RANS

Airworthiness Directive: 135

Date: September 25, 2007

Subject: CAB-TANG Failure

Inspection Location:

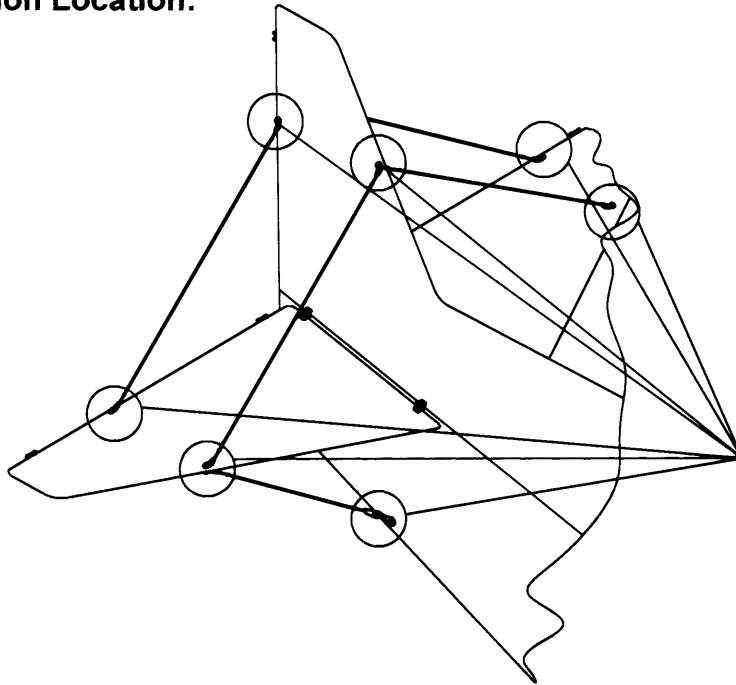
INSPECT ALL TAIL
CABLES AND TANGS

Option 1 - Inspect all cables at 50 hour intervals and at condition inspection. Replace if cracks or defects are found.

Option 2 - Replace cable with latest revision and inspect at condition inspection. Contact RANS Parts Department for replacement parts.

Inspection Procedure:

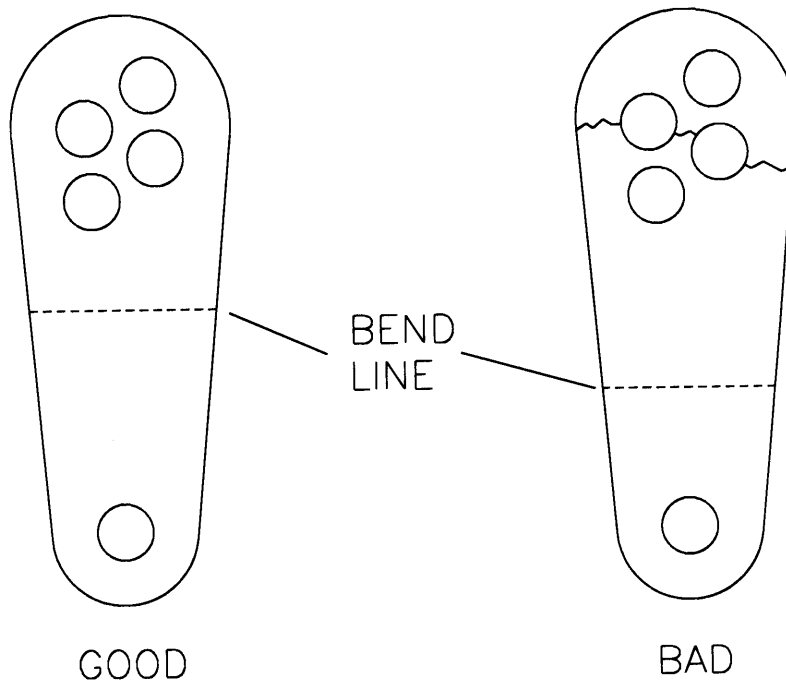
Remove bolts holding the CAB-TANG and inspect the tangs using a 10X magnifier.
